**Re: Peer Review
Surfside Commons Apartments
106 Surfside Road, Nantucket, MA**

On behalf of the Nantucket Planning Board, Tetra Tech (TT) has completed a peer review of the October 6, 2015 *Traffic Assessment* prepared by Bristol Traffic & Transportation Consulting LLC for the proposed project located at 106 Surfside Road in Nantucket, Massachusetts. We have also reviewed supplemental information provided to the town on May 6, 2016. The supplemental information included the following documents:

PROFILES

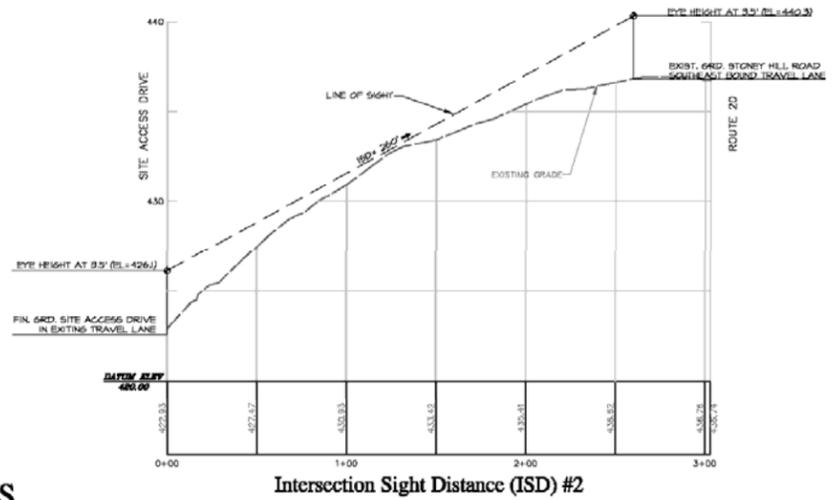
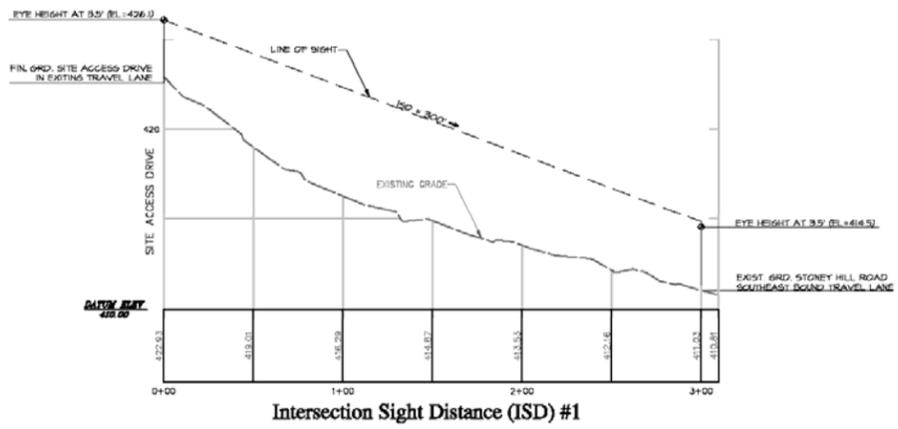
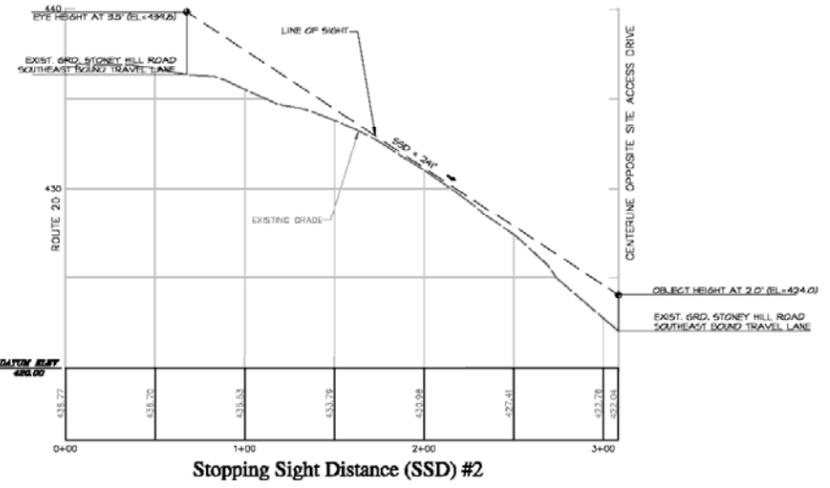
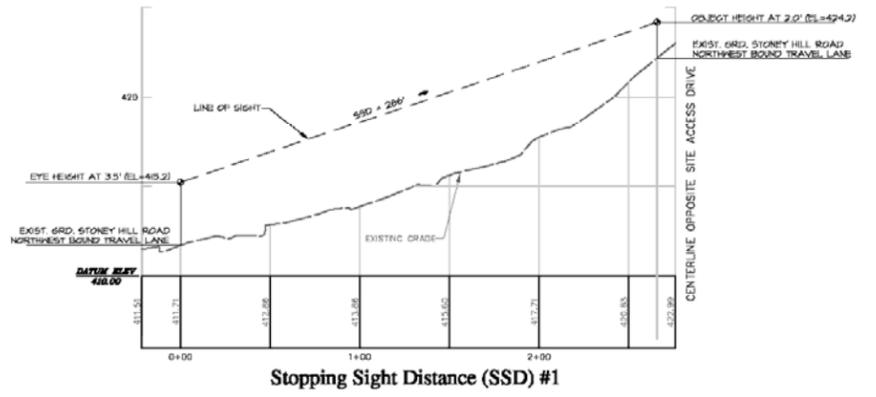
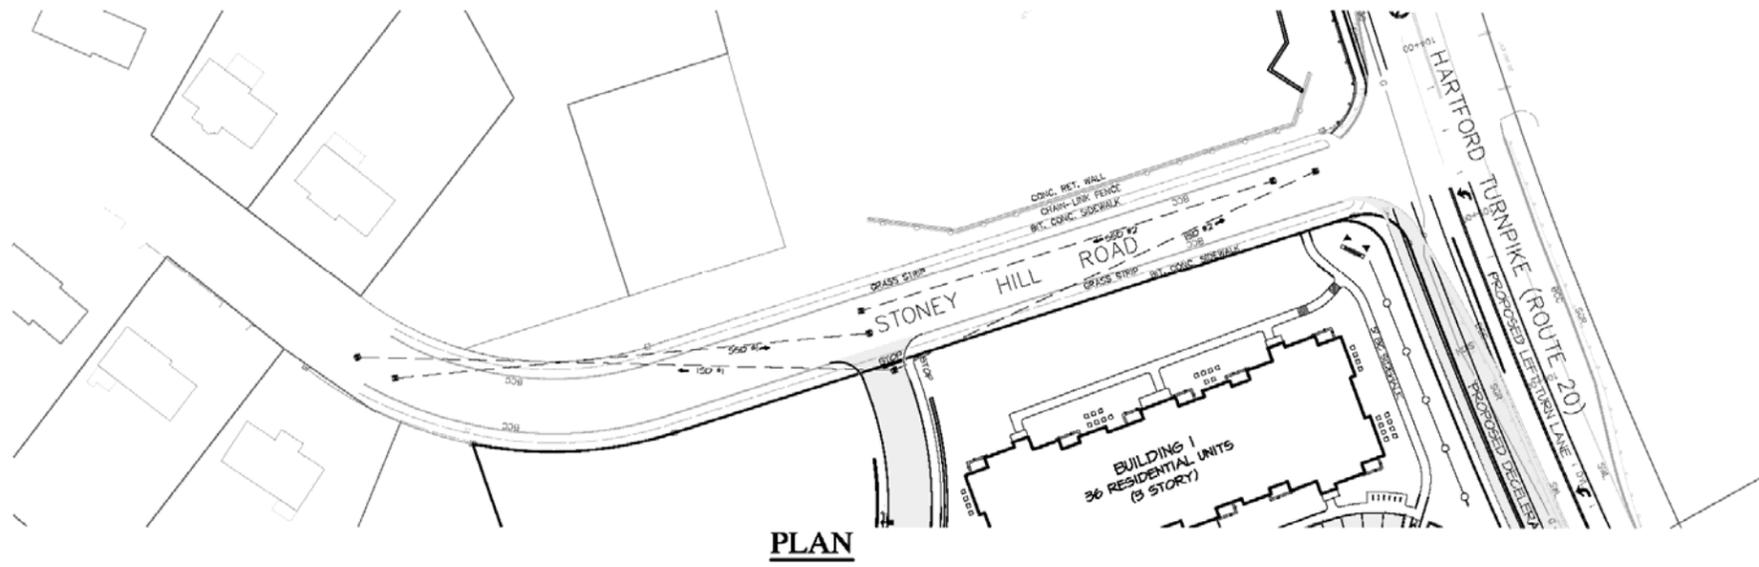
- The sight line profile provided for the north leg of the intersection is difficult to read due to its scale. A profile for both legs of Surfside Road should be provided utilizing a more appropriate vertical scale (see attached example). The profile should clearly show the Stopping Sight Lines (from a point 3.5 feet above the pavement to a point 2.0 feet above the pavement at the intersection) and the Intersection Sight Lines (from an appropriate distance from the edge of travel way (typically 14.5 feet) and 3.5 feet above the proposed driveway grade to a point 3.5 feet above the existing pavement along Surfside Road). The profile should reflect the position of the stopped vehicle on the site driveway. This distance may exceed 14.5 feet due to the proposed bike path. The existing guard rail and any other obstructions along the east side of Surfside Road should be plotted on the profile to confirm they will not block the sight lines for vehicles turning from the driveway.
